APP 04

Application Number: 12/01651/DISCON

Details submitted pursuant to discharge of conditions 2 (materials), 7 (surface water disposal from vehicular access), 8 (highway works at junction of Church Road and London End Lane), 10 (surfacing of vehicle and pedestrian areas), 11 (details of earth mounding and contouring), 16 (landscaping scheme), 17 (works to trees) and 18 (boundary enclosure) attached to planning permission 08/01721/FUL allowed by appeal ref APP/Y0435/A/09/2104644

AT Land West of, 1 London End Lane, Bow Brickhill

PROPOSED SITE PLAN

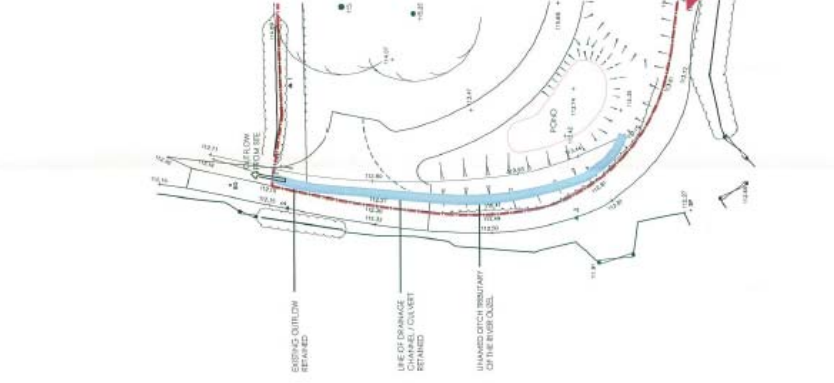
- A3.19 Condition 11 (details of earth mounding and contouring)
The plans for mounding seem to include earthworks outside the site and that is not acceptable (the plans have 'new mounding to kept away from existing planting' written on the footpaths). The new mounding is shown within the site boundary and not on the footpath.
